Airworthiness Directives; Cessna Aircraft Company Models 150, 152, 170, 172, 175, 177, 180, 182, 185, 188, 190, 195, 206, 207, 210, T303, 336, and 337 Airplanes

ACTION: Final rule.

2011–10–09 Cessna Aircraft Company:
Amendment 39–16690; Docket No. FAA–2010–1101; Directorate Identifier 2009–CE–013–AD.

Figure 1. Diameter of seat pin locking engagement hole

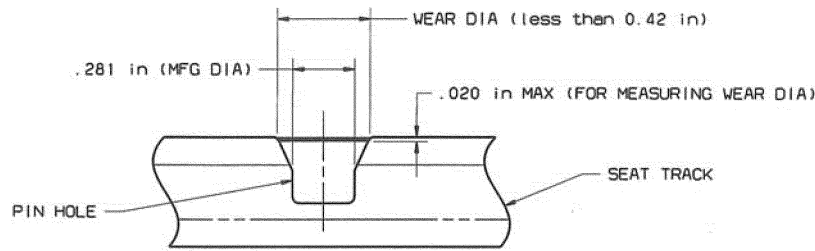
Dave McFarlane requested we add a maximum allowable incremental 0.07-inch radius dimension to figure 1 at the outside diameter dimensions for clarification.

We disagree with this comment. The measurement dimensions in figure 1 adequately address the measurements necessary for this AD. Additional measurements will not provide any additional benefit.

Figure 4. Closeup of seat roller housing and tang gap width

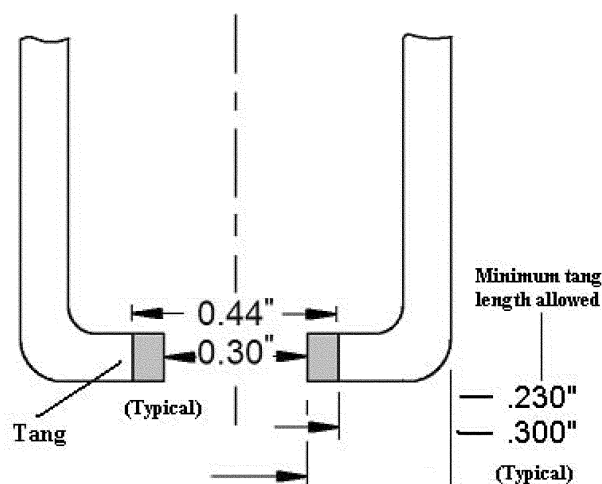
Brian A. Andrus, Jim Currie, and Jerry Unruh requested we change the tang measurement to the outside of the seat roller housing and change the description of the tang measurement. This change would make it easier for the inspector to take the measurement and to better understand what is being measured.

We agree with this comment. We agree that measuring the tang length inside of the roller housing is difficult because of the presence of the rollers inside of the roller housing.

We have changed the callouts in figure 4 to measure the tang length from outside of the roller housing instead of from inside of the roller housing. We have also changed the description of the tang measurement in figure 4 to more accurately describe the measurement.
